To: Oshawa Active Transportation Advisory Committee (OATAC)

From: Projects Working Group Draft 2023-03-10

Subject: Durham Meadoway Visioning Study

To respond to the Region of Durham request for comments regarding the Region of Durham Meadoway Visioning Study.

Exhibit 1

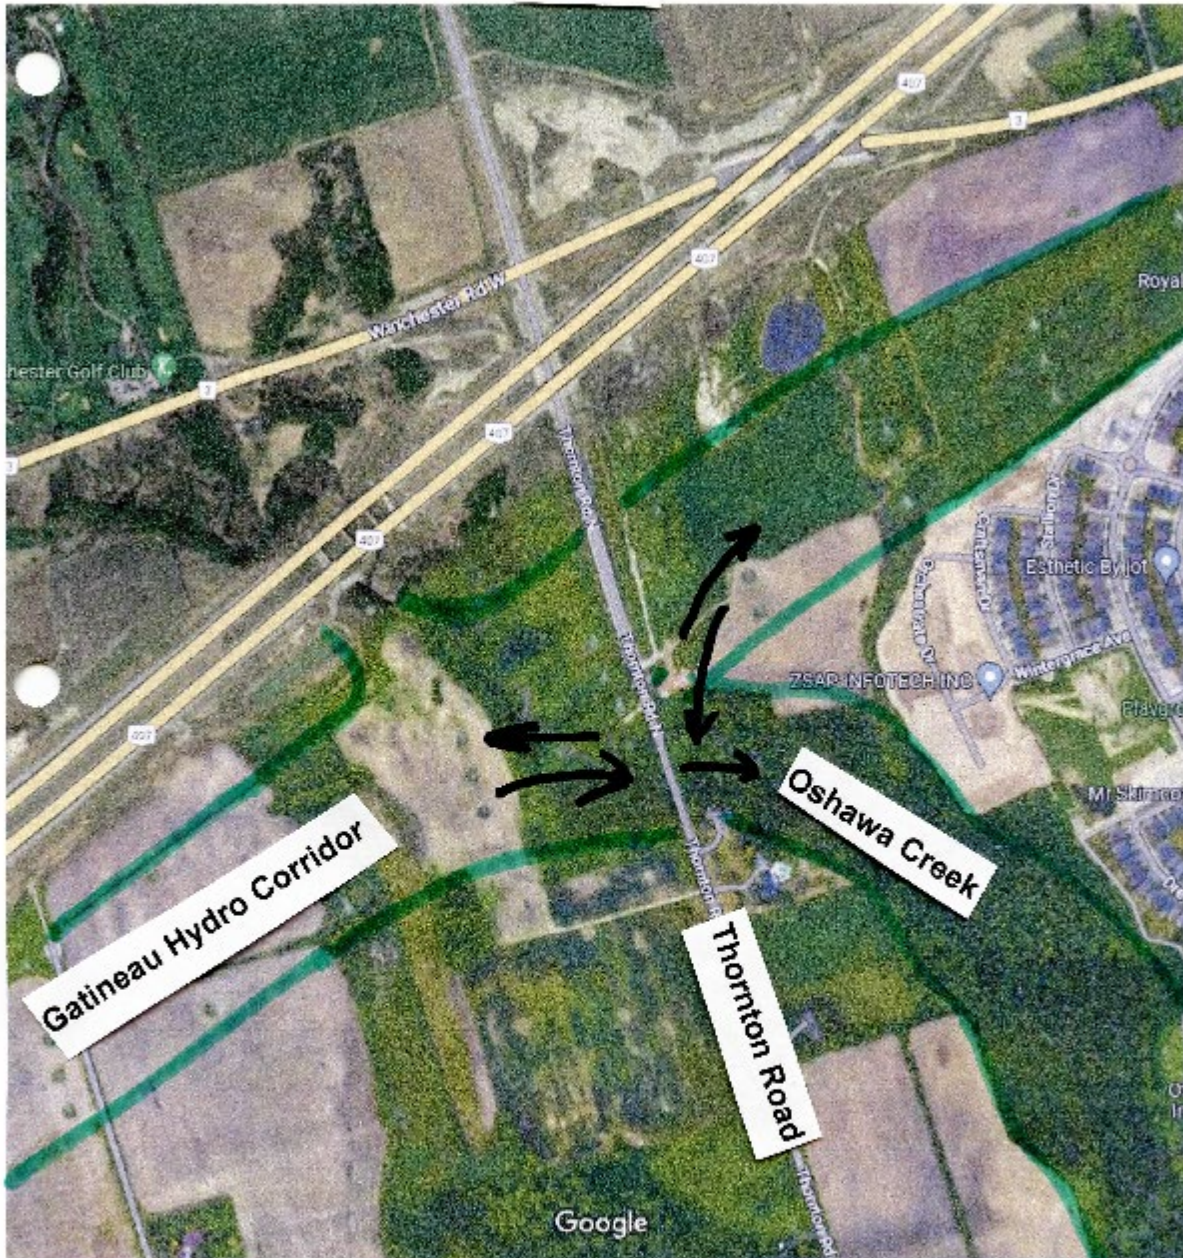
- 2.2 That the City request the consultant for the Thornton Road design to provide an estimate of the cost of providing a grade separated underpass for walking and cycling under Thornton Road for both the users of the Oshawa Creek Valley and Gatineau Hydro Corridor. Exhibit 1.

- 3.2 Thornton Road is the most westerly road intersecting this hydro corridor in Oshawa. The road is under design for both a two and four lane cross-section. One branch of the Oshawa Creek Valley runs under Thornton Road adjacent to this hydro corridor. The opportunity exists to design the Oshawa Creek underpass of Thornton Road to accommodate both the Oshawa Creek trail users and the Hydro Corridor patrons. The consultants for the Thornton Road design should be requested to identify the cost of providing a grade separated crossing for active transportation in the Oshawa Creek Valley to accommodate both trail users.
